6/12/78	Revised 6th and 7th line of Legend
DATE	REVISION
STATE OF HAWAII DEPARTMENT OF TRANSPORTATION HIGHWAYS DIVISION	
KEEHI INTERCHANGE ELECTRICAL PLAN - PART I	
INTERSTATE ROUTE H-1 PROJECT NO. I-HI-1(130):17	
SCALE: NONE	DATE: AUG. 16, 1976
SHEET No. E1 OF E12 SHEETS

8/3/77	RELOCATED COLUMN MOUNTED LUMINAIRE FOR AT GRADE ROADWAY FROM RAMP II TO RAMP I
DATE	REVISION
STATE OF HAWAII DEPARTMENT OF TRANSPORTATION HIGHWAYS DIVISION	
KEEHI INTERCHANGE ELECTRICAL PLAN - PART II STAGE II CONSTRUCTION	
INTERSTATE ROUTE H-1 PROJECT NO. I-HI-1 (130):17	
SCALE: N.T.S.	DATE: AUG. 16, 1976
SHEET NO. 52 OF 52 SHEETS

8/3/77	RELOCATED UNDERGROUND RACEWAY AND RUN-UP AT COLUMN FROM RAMP II TO RAMP I
DATE	REVISION
STATE OF HAWAII DEPARTMENT OF TRANSPORTATION HIGHWAYS DIVISION	
KEEHI INTERCHANGE ELECTRICAL PLAN - PART III STAGE II CONSTRUCTION	
INTERSTATE ROUTE H-1 PROJECT NO. I-HI-1(130):17	
SCALE: 1" = 50'	DATE: AUG. 16, 1976
SHEET No. E3 OF 12 SHEETS

DETAIL 2/E2 LUMINAIRE MOUNTINGS RAMPS I & II

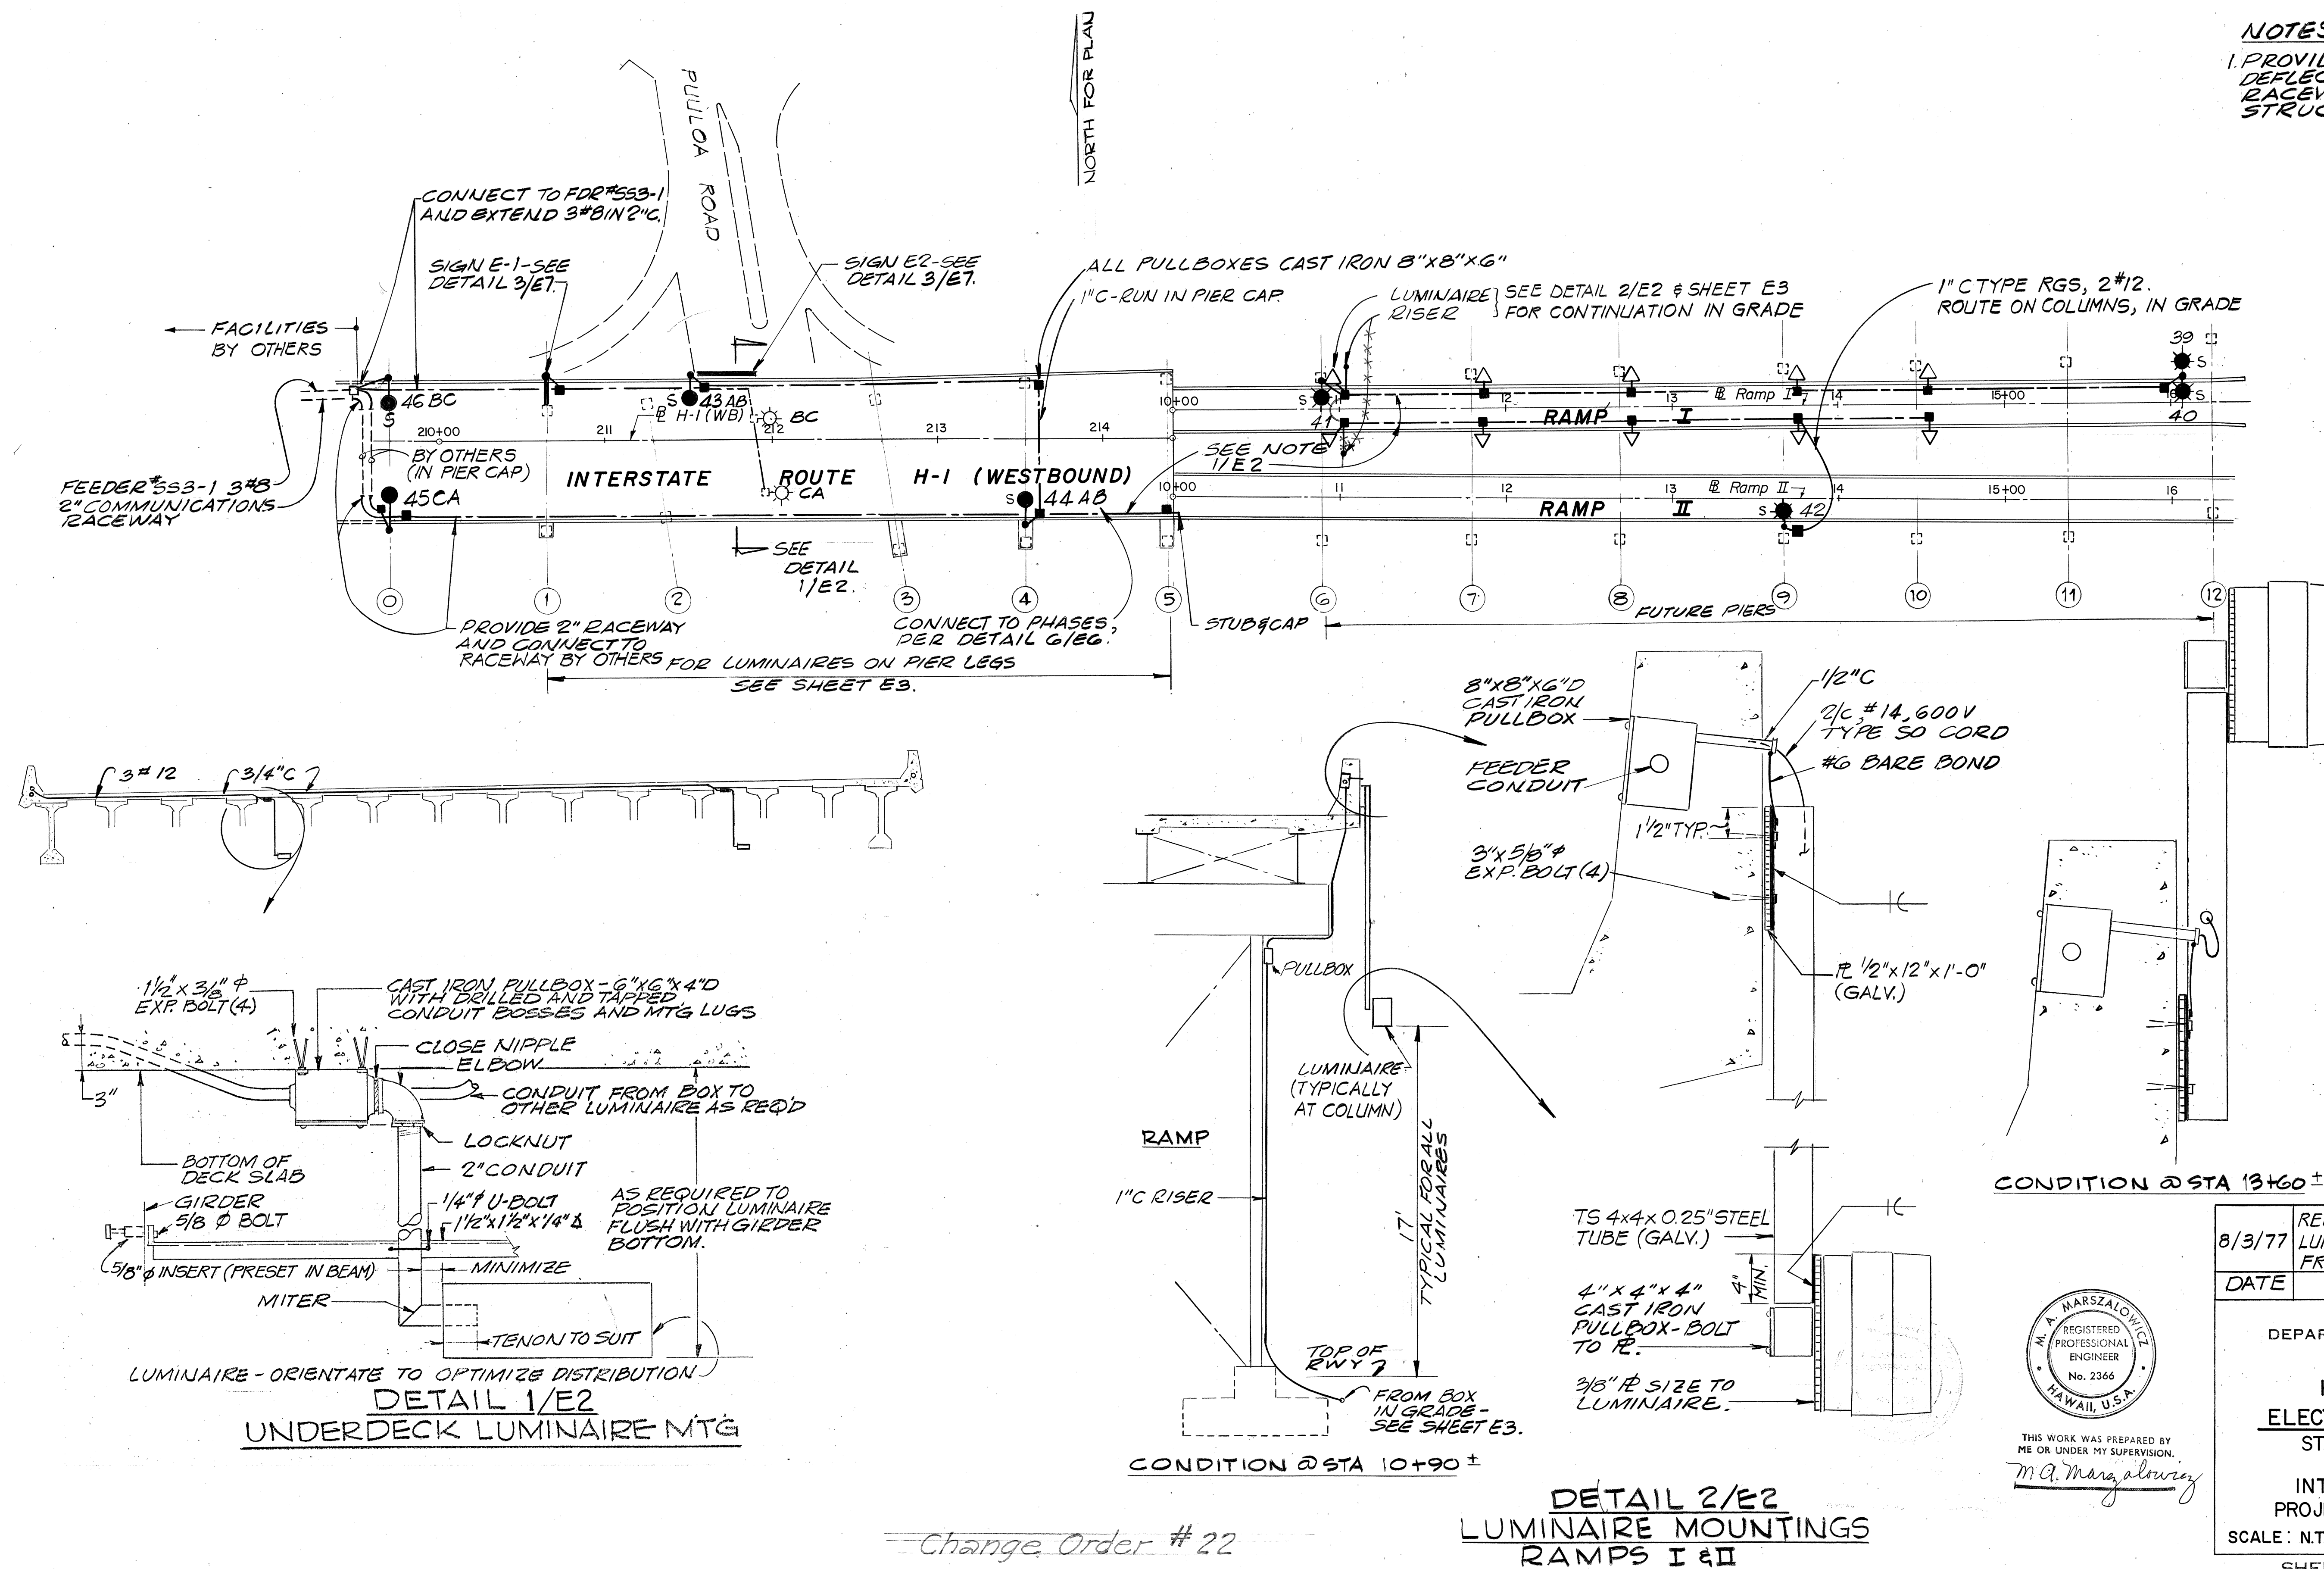
Change Order #22

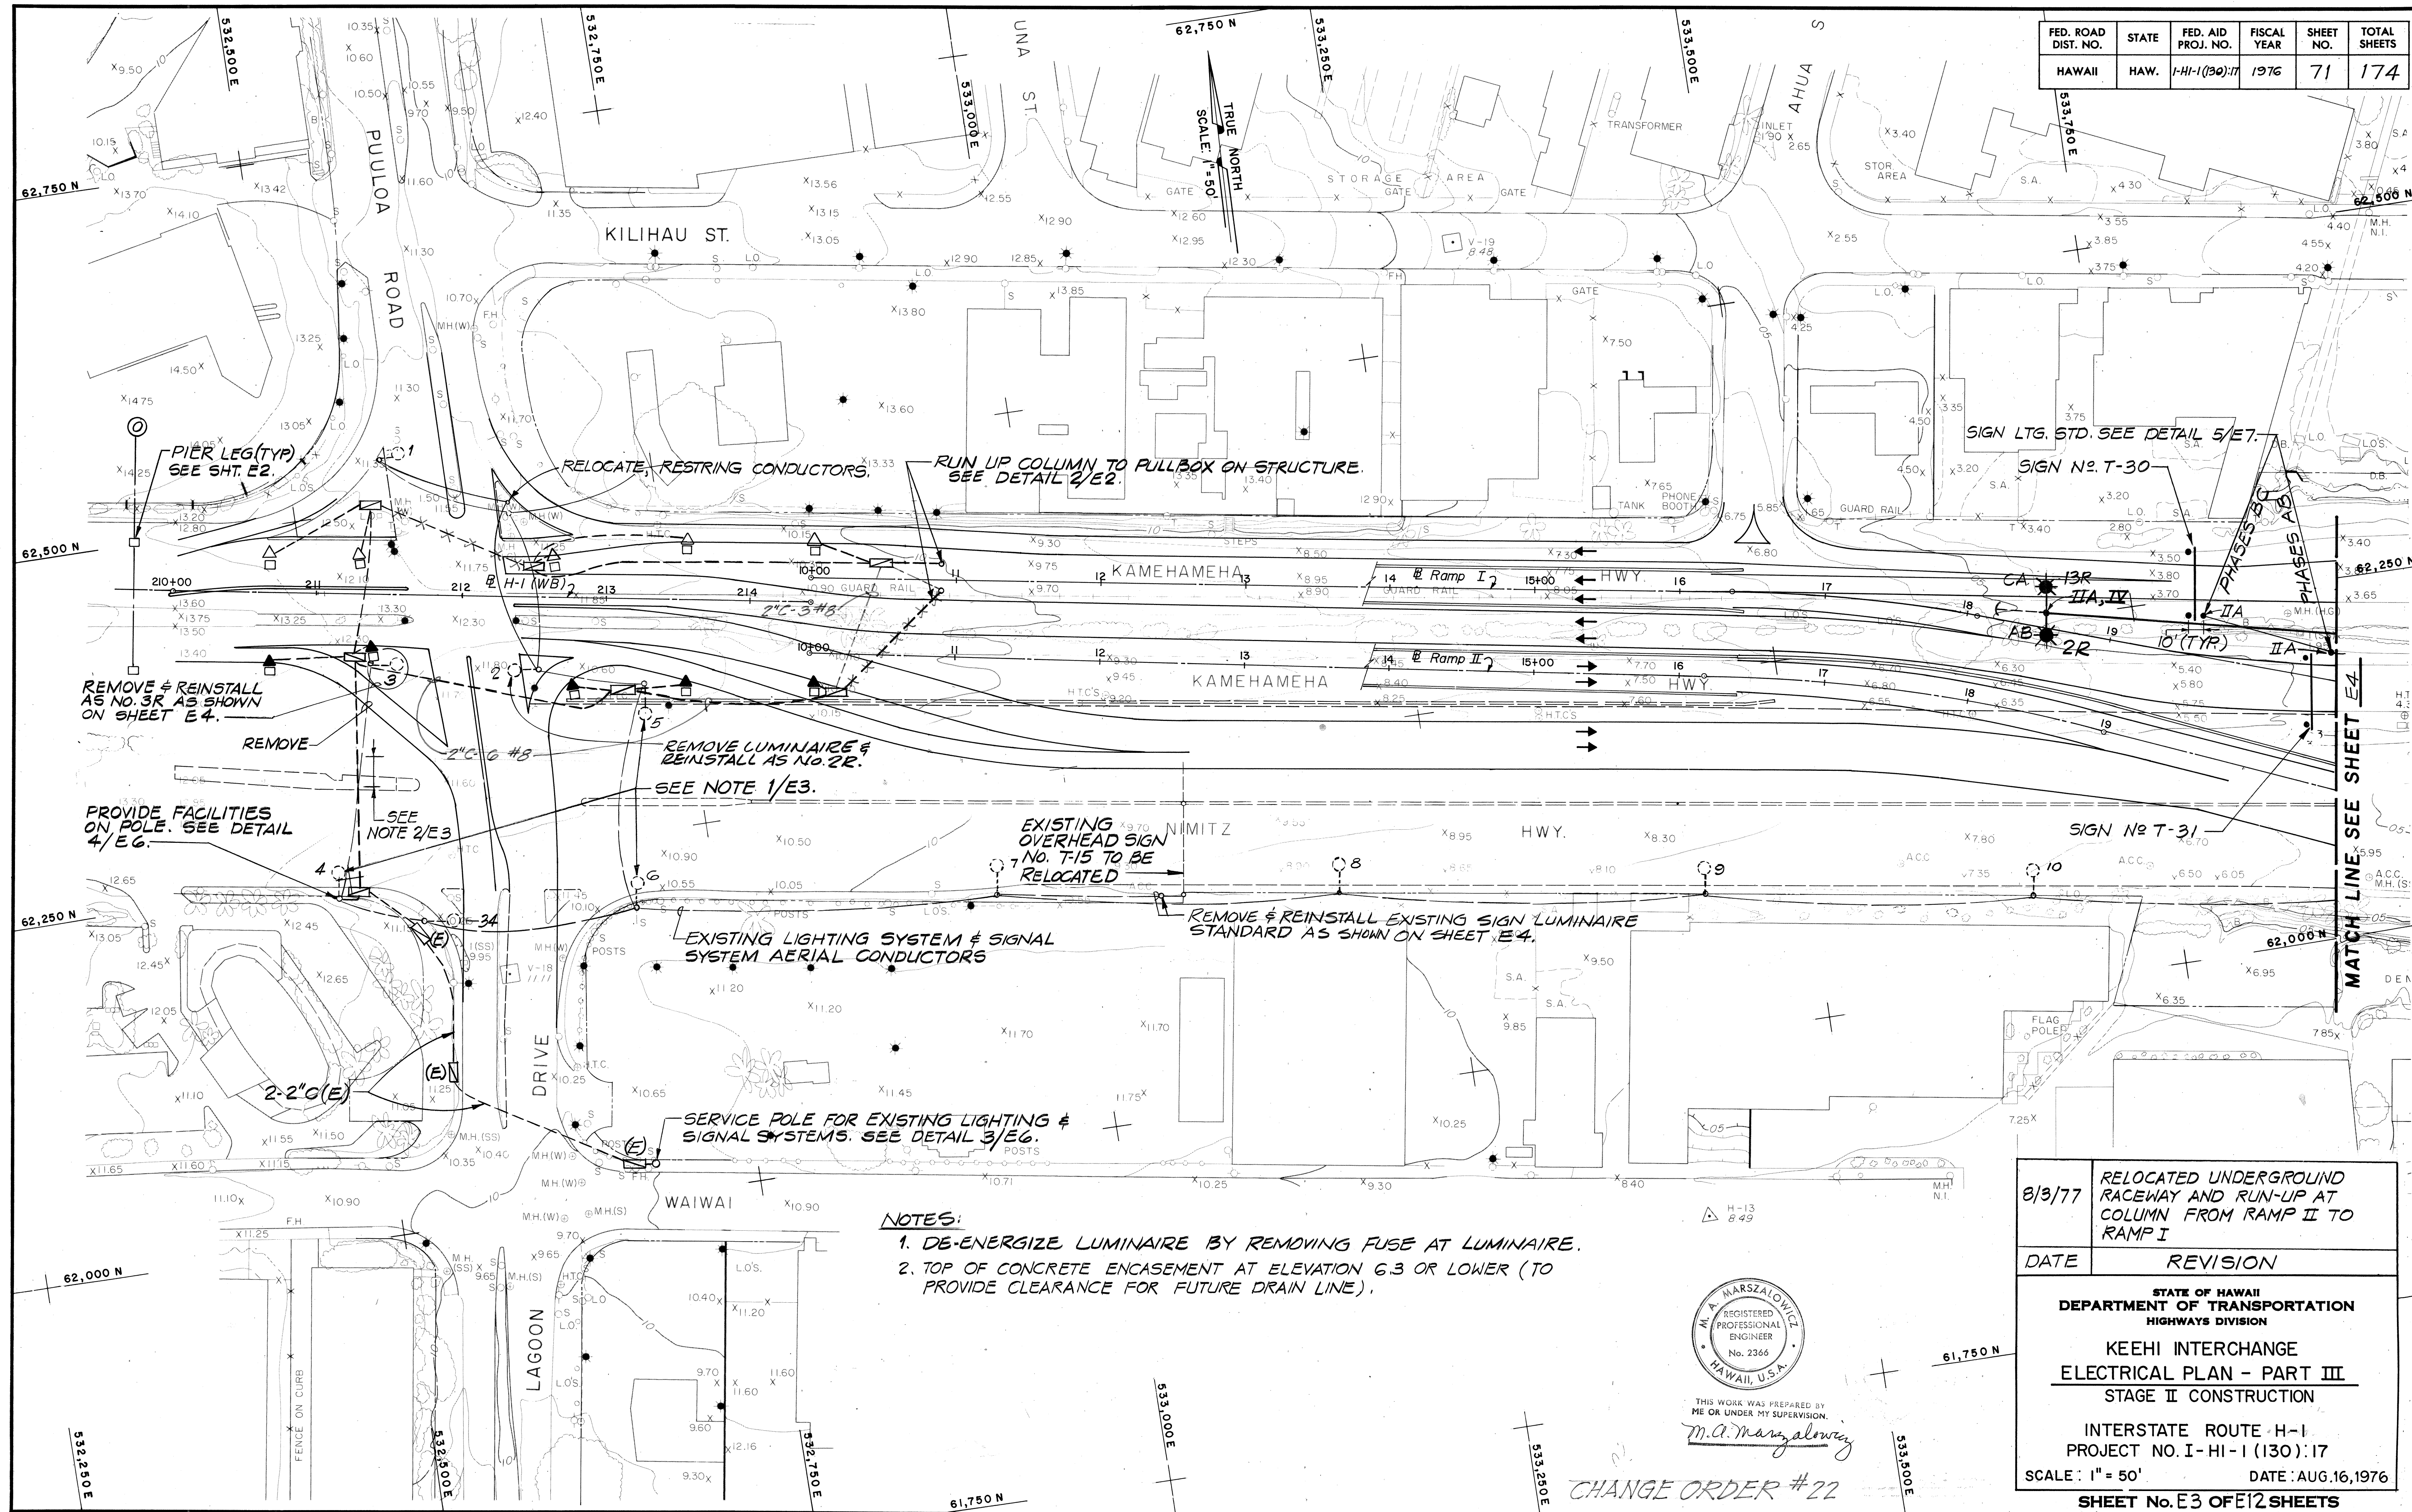
CHANGE ORDER #22
